PRODUCT ADVISORY

Data Sheet Specification Correction for Intersil Product ISL59446*

**Refer to:
PA10088**

Date: August 27, 2010

L32.5x6A (One of 10 Packages in MDP0046)
32 LEAD QUAD FLAT NO-LEAD PLASTIC PACKAGE
(COMPLIANT TO JEDEC MO-220)

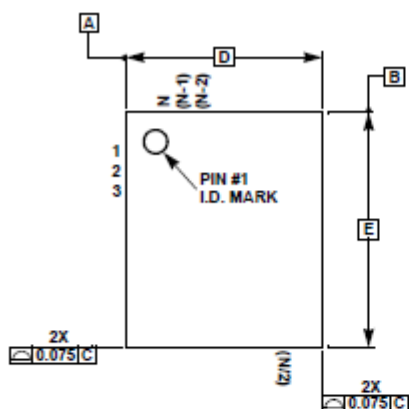
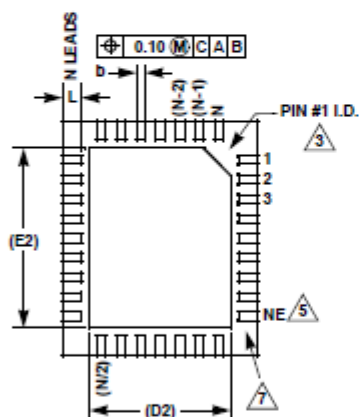
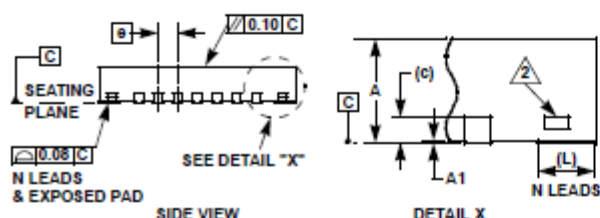
This advisory is to inform you that Intersil has made corrections to the POD (Package Outline Drawing) referenced in the data sheet specification for the ISL59446* products. The updates to the POD correct the lead width ("b") minimum and maximum dimensions. There have been no changes made to the package or product itself. The updated data sheet incorporating the corrected POD is available on the Intersil web site at <http://www.intersil.com/data/fn/fn6261.pdf>.

SYMBOL	MILLIMETERS			NOTES
	MIN	NOMINAL	MAX	
A	0.80	0.90	1.00	-
A1	0.00	0.02	0.05	-
D	5.00 BSC			-
D2	2.48 REF			-
E	6.00 BSC			-
E2	3.40 REF			-
L	0.45	0.50	0.55	-
b	0.17	0.22	0.27	-
c	0.20 REF			-
e	0.50 BSC			-
N	32 REF			4
ND	7 REF			6
NE	9 REF			5
